**GEARY ELEMENTARY / MIDDLE SCHOOL
PAVEMENT REPAIR AND IMPROVEMENTS**

ADDENDUM #2

JUNE 2, 2021

THRASHER PROJECT #060-0989

SHEET No.
C2.02R1

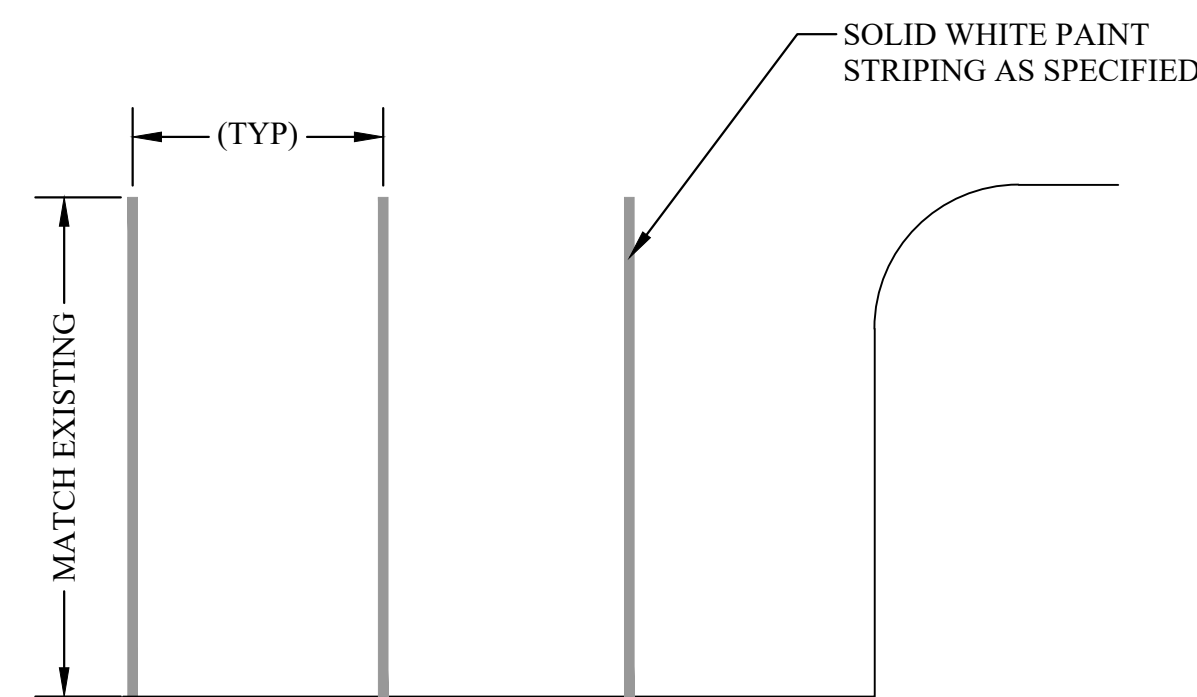
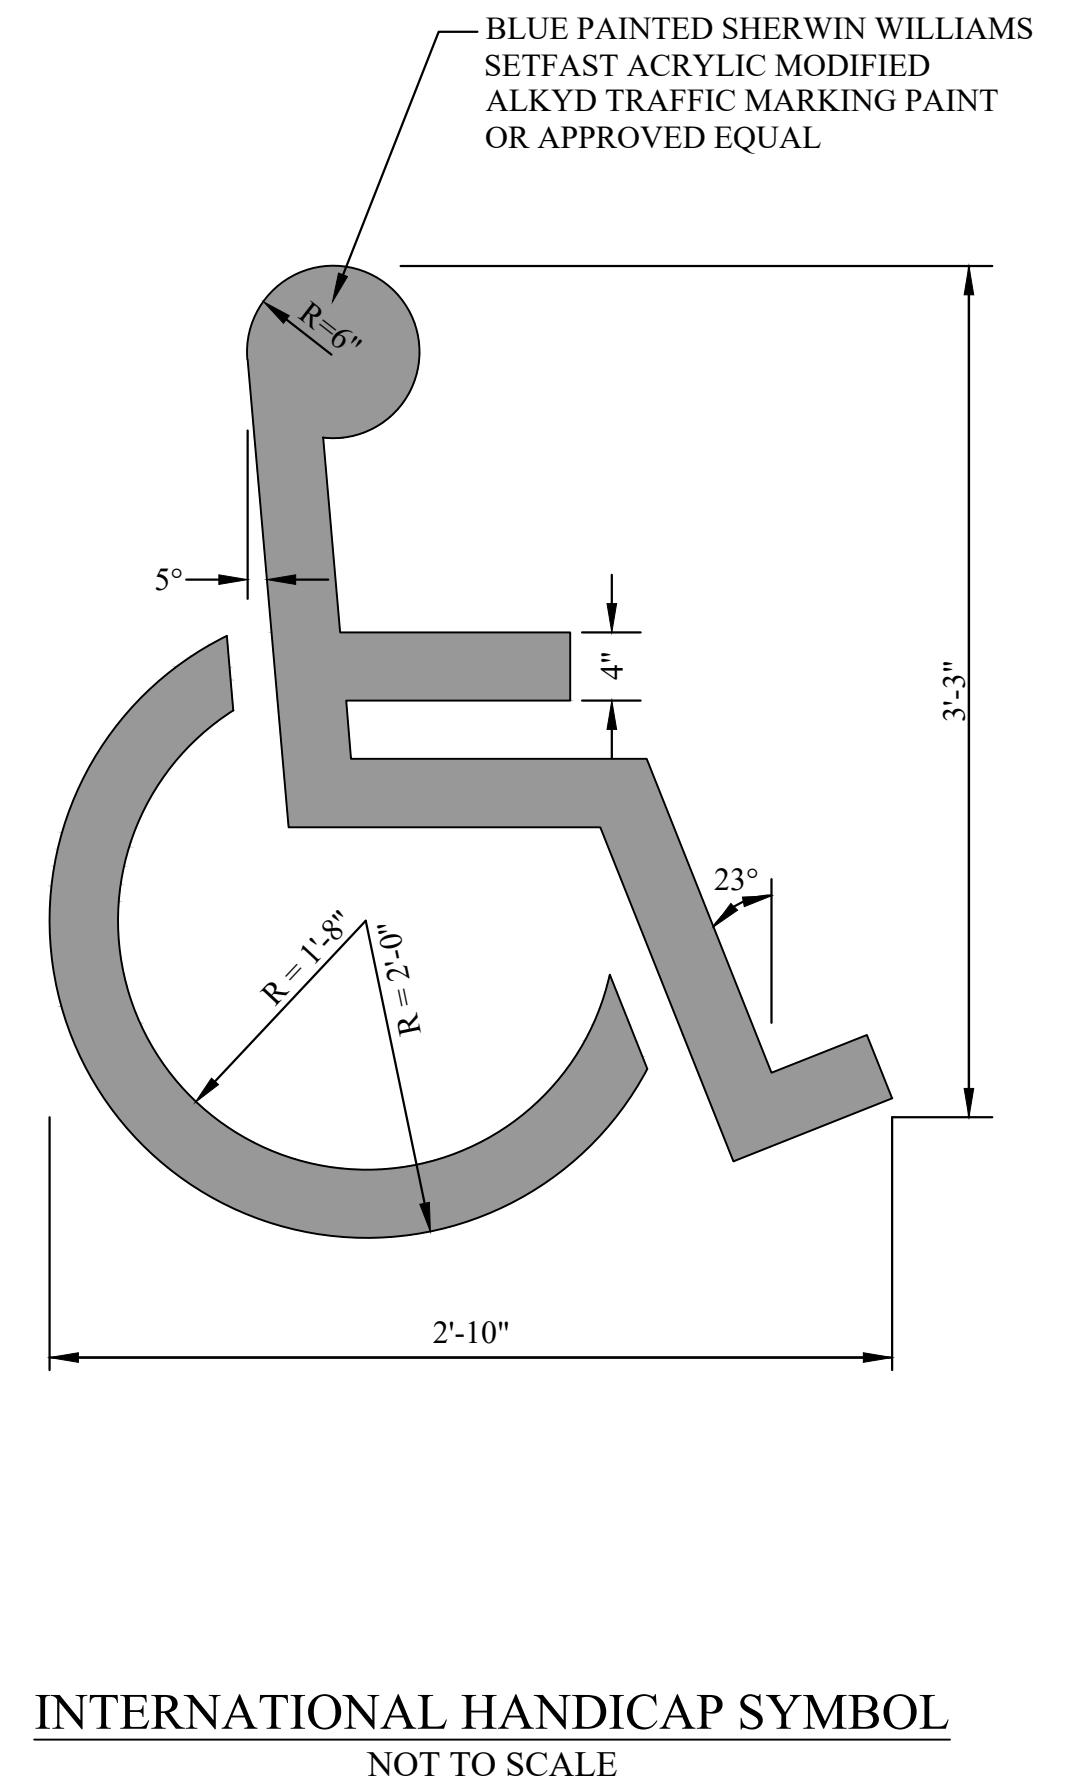
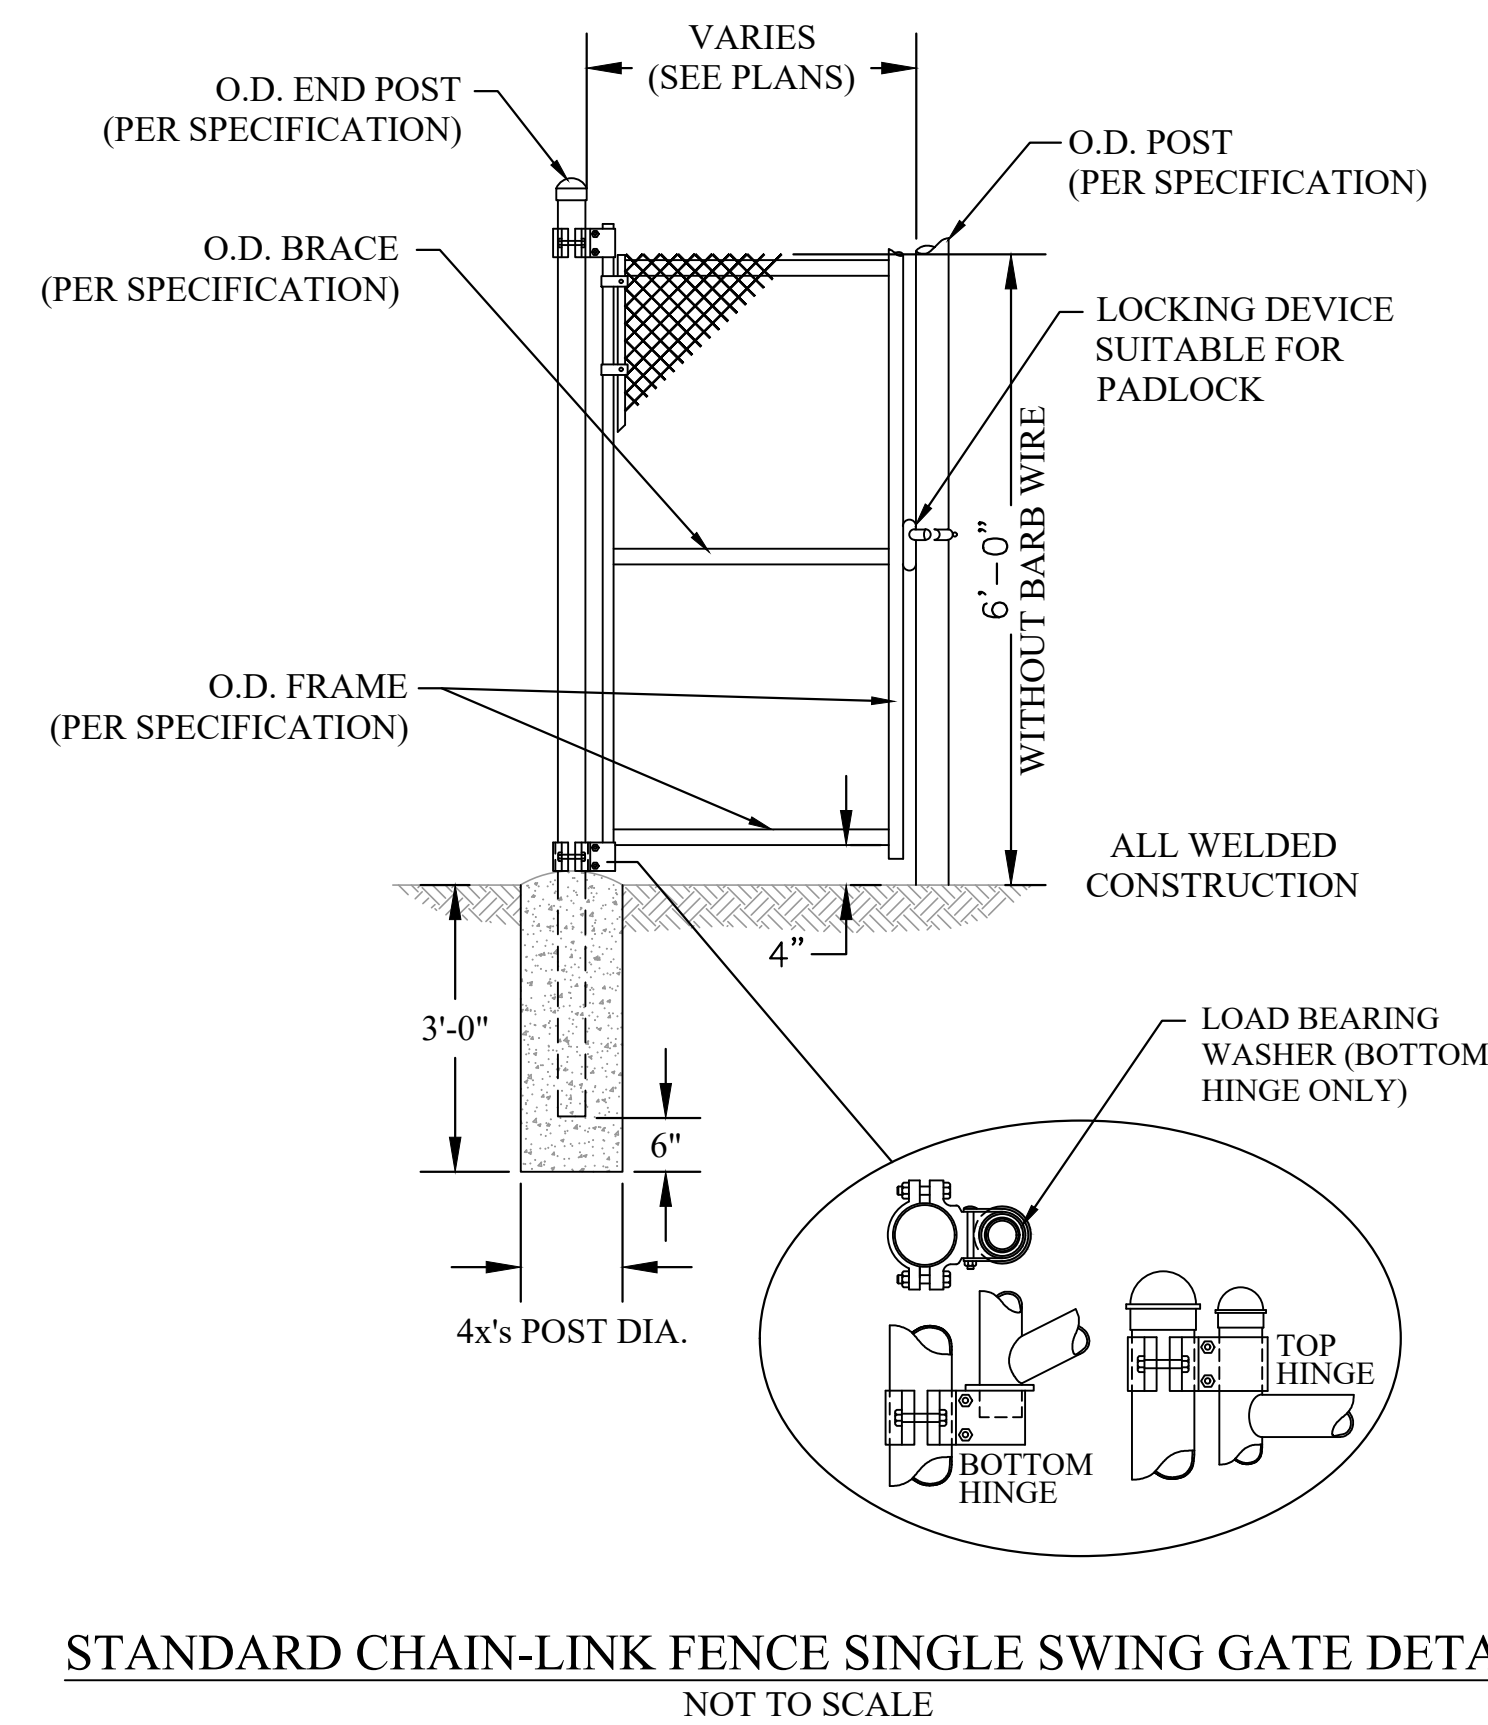
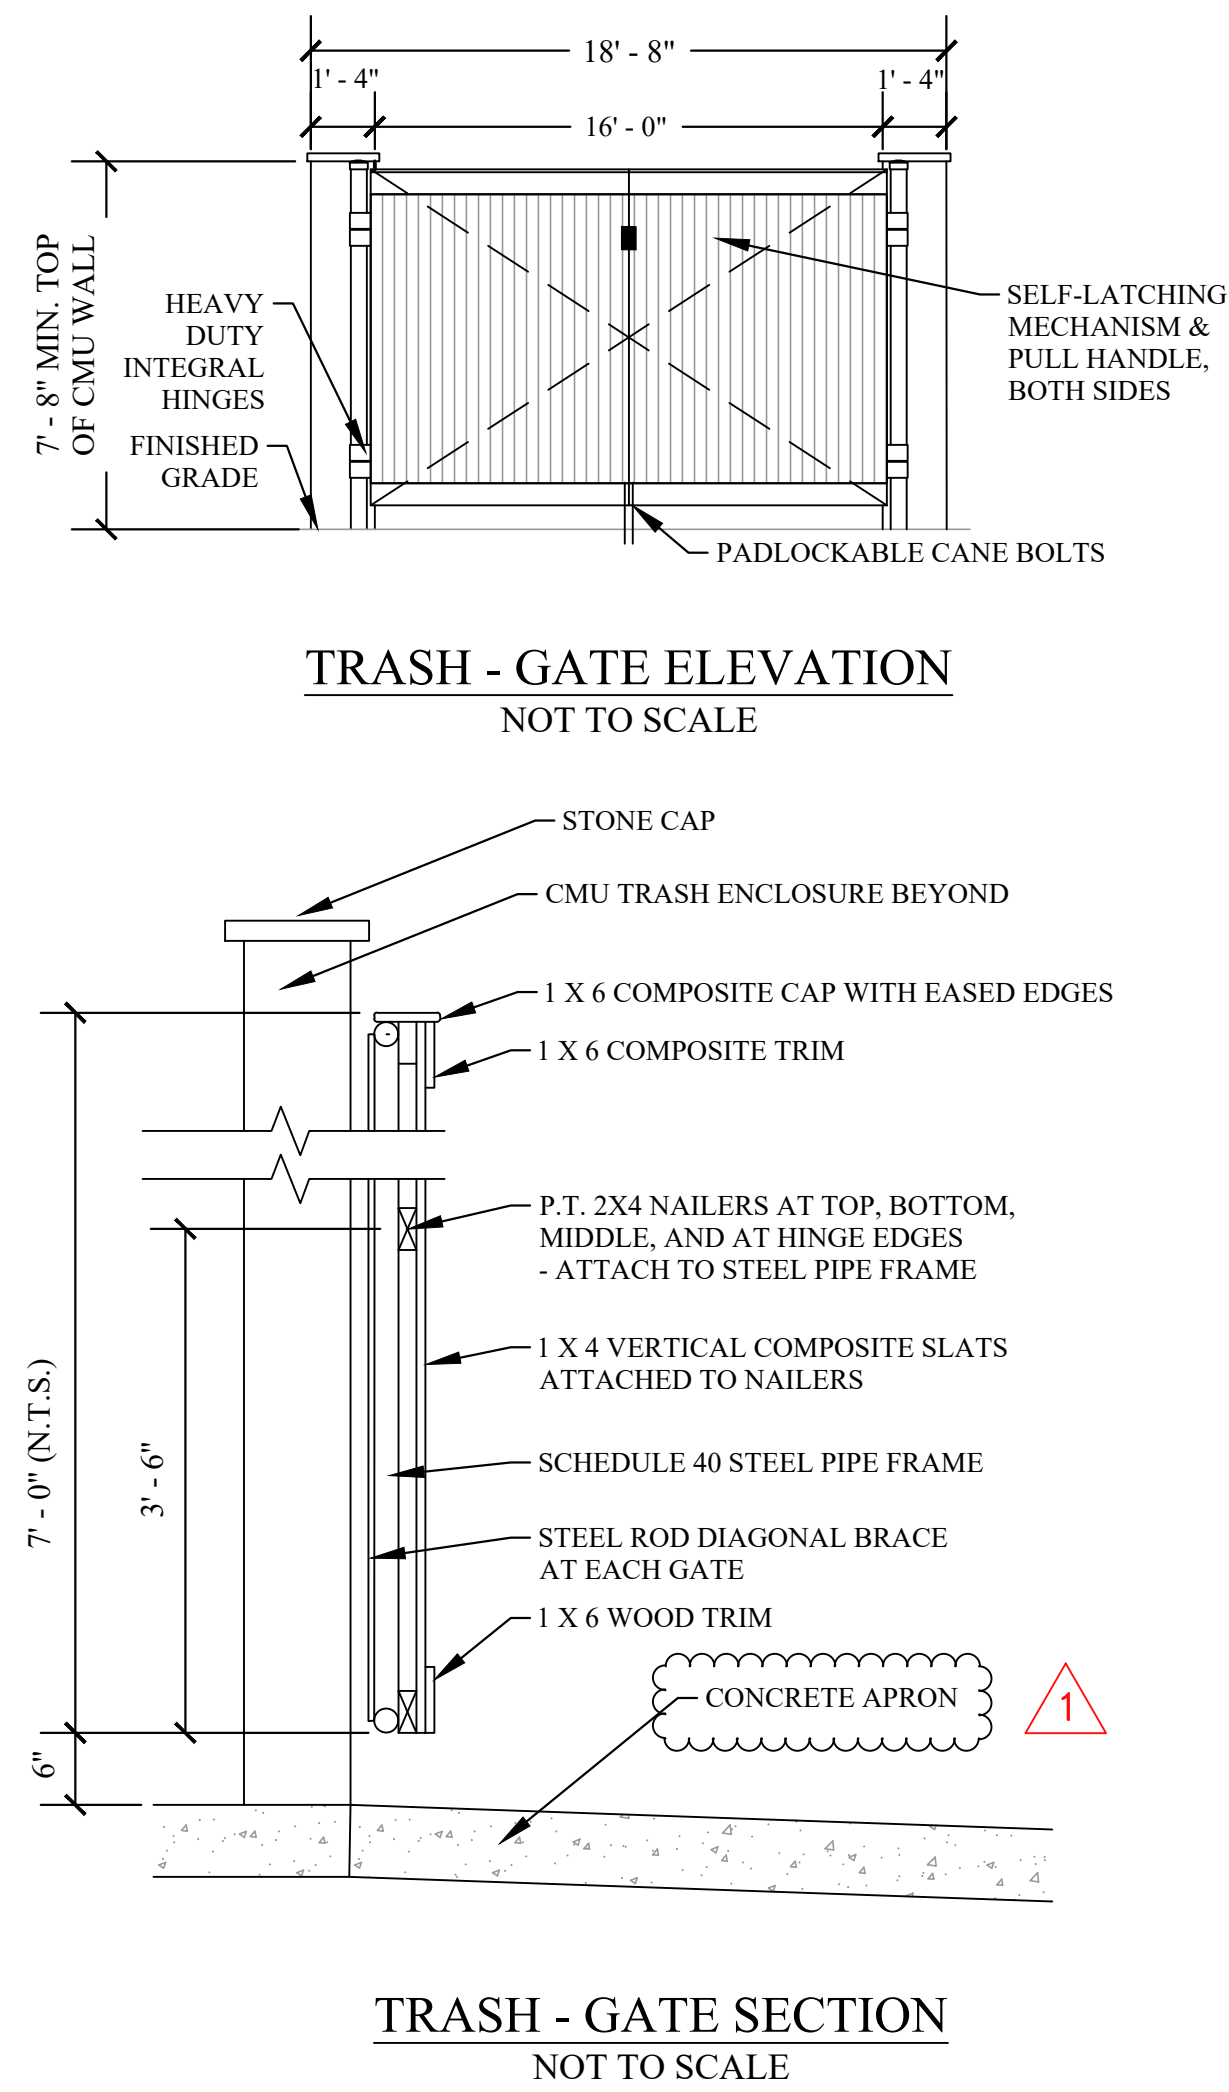
NO.	BY	DATE	DESCRIPTION
1	CLM	06/01/21	ADDED CONCRETE APRON AND SLAB SECTION DETAILS.
